SUNDRY NOTICES AND REPORTS ON WELLS

8. Well Name and No.
SKELLY UNIT 52

9. API Well No.
30-015-05345-00-D1

PROPOSED PLUGGING PROCEDURE:
1. Set 5 1/2 CIBP @ 3006'. Circulate hole w/mud laden fluid
2. Spot 25 sx cmt @ 3006'-2856'
3. Perf 10 shots @ 2319'-2349' – existing Perfs
4. ~~Sqz 45~~ sx cmt @ 2400'-2270' WOC & Tag
5. Perf & Sqz 40 sx cmt @ 1640'-~~1540'~~ WOC & Tag 1520'
6. Perf & Sqz 50 sx cmt @ 715'-~~615'~~ WOC & Tag 562'
7. Perf & Sqz 85 sx cmt @ 200'-surface

Original Hole, 7/14/2016 1:53:18 PM

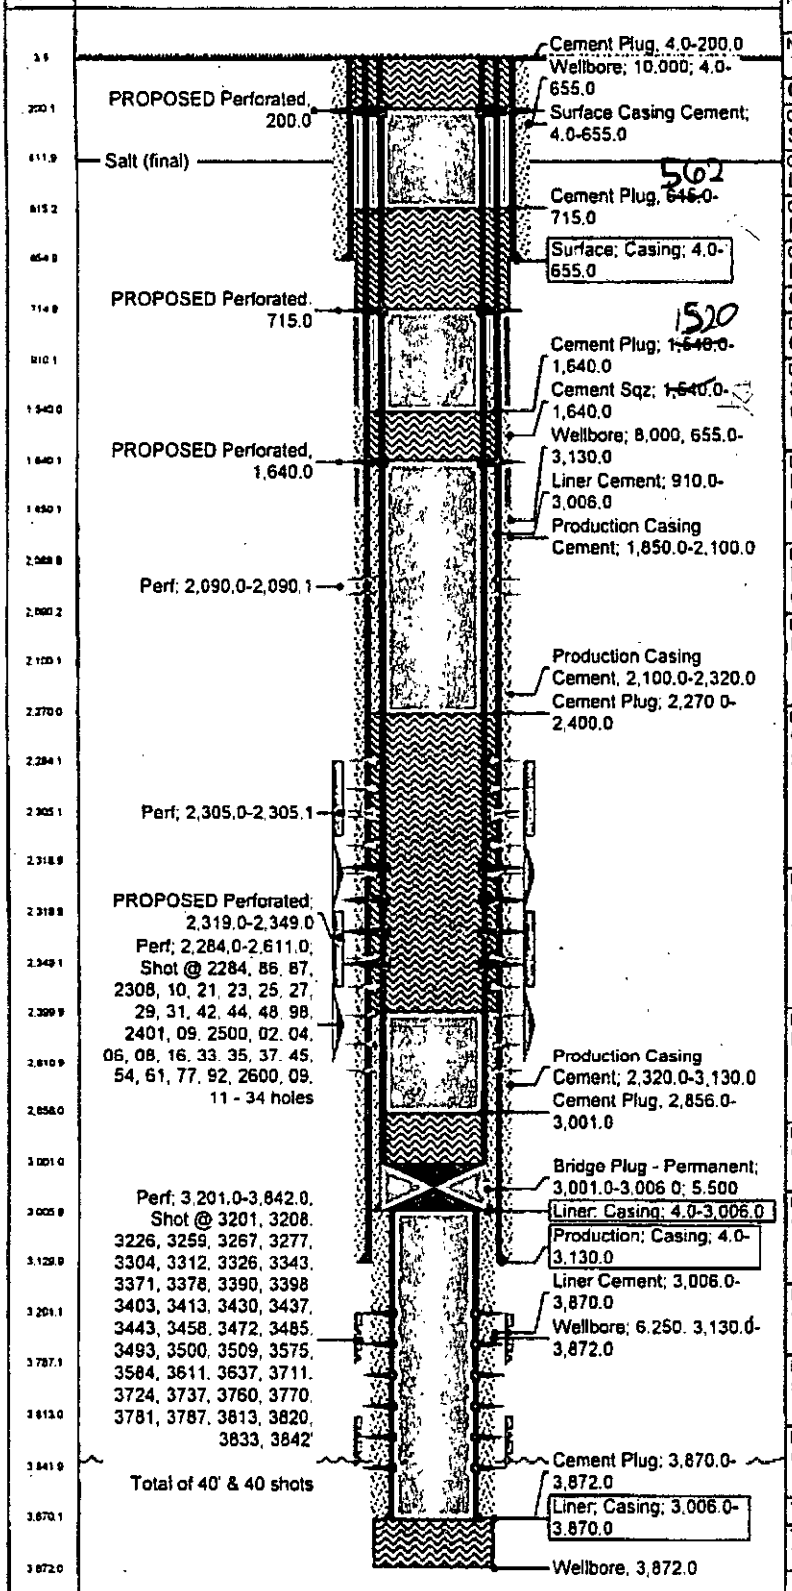
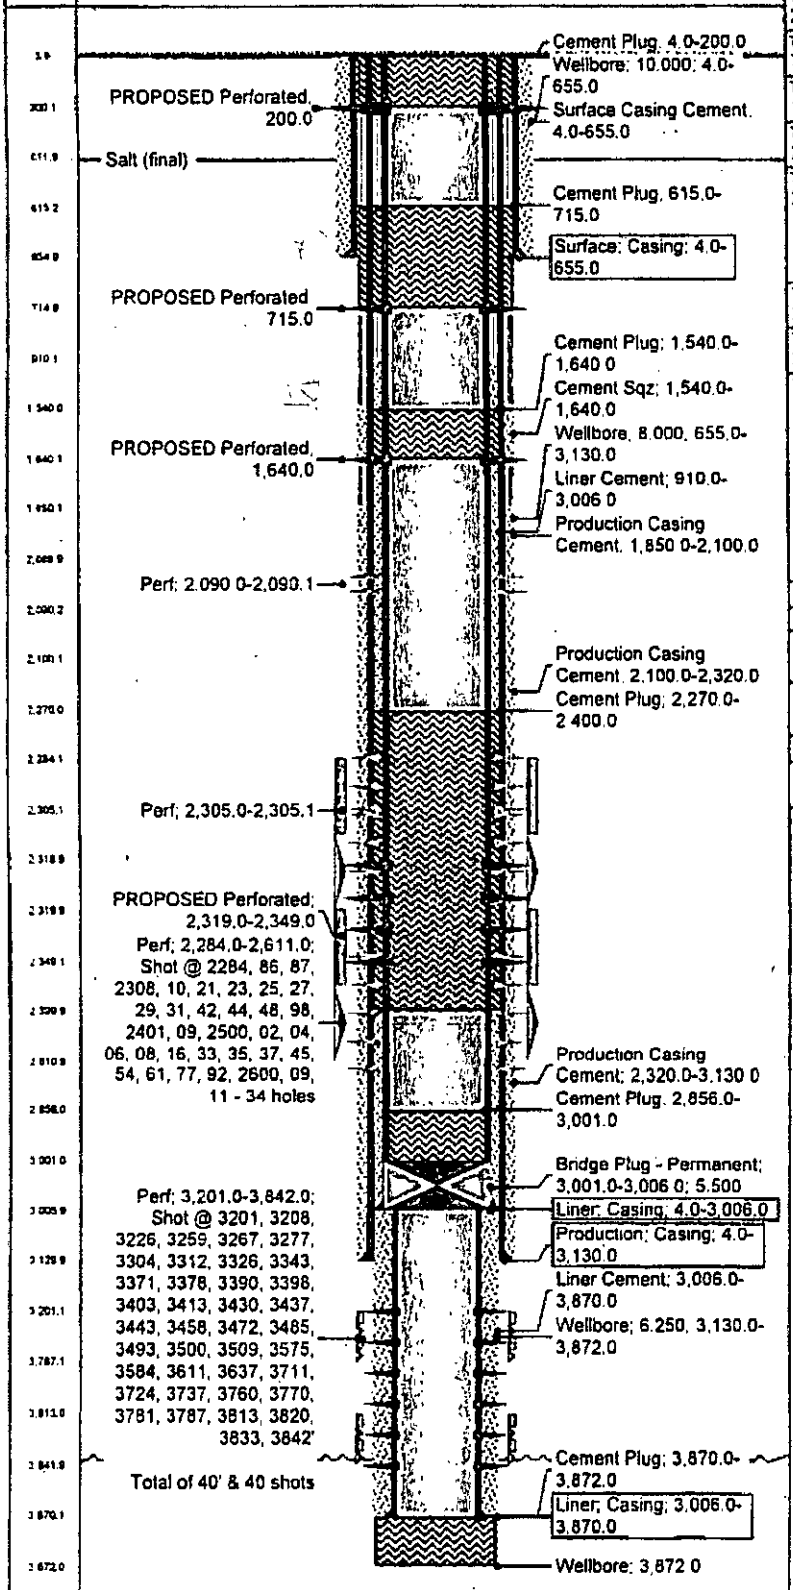
Spot 25sx

Below Ground level abandonment marker required
